SERVICE BULLETIN

PURPOSE : CORRECTION	ISSUE NO. : MSB-08E23-502	DATE : 2008-02-05
SUBJECT : A/T FLUID TEMPERATURE SENSOR CHECK	<div> <div><MODEL></div> <div>(EUR)</div> <div>OUTLANDER</div> <div>(GS45X)(CW0W)</div> </div> <div> <div><M/Y></div> <div>07-</div> </div>	
GROUP : AUTOMATIC TRANSMISSION

A/T FLUID TEMPERATURE SENSOR CHECK

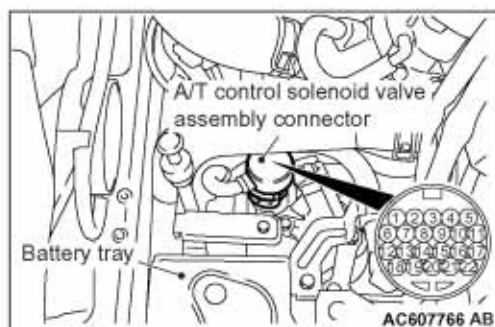
1. Disconnect the A/T control solenoid valve assembly connector. **and No. 3 <Added>**
2. Measure the resistance between the sensor-side connector terminal No. 2 of the A/T control solenoid valve assembly connector **and the earth.**

Standard value: **<Deleted>**

Fluid temperature °C	Resistance kΩ
10	Approx. 6.62
25	Approx. 3.51
80	Approx. 0.55
110	Approx. 0.25

3. When the resistance of the A/T fluid temperature sensor is outside the standard value, and the fluid temperature warning comes on/goes out at other than the specified temperatures, replace the valve body assembly and the harness.
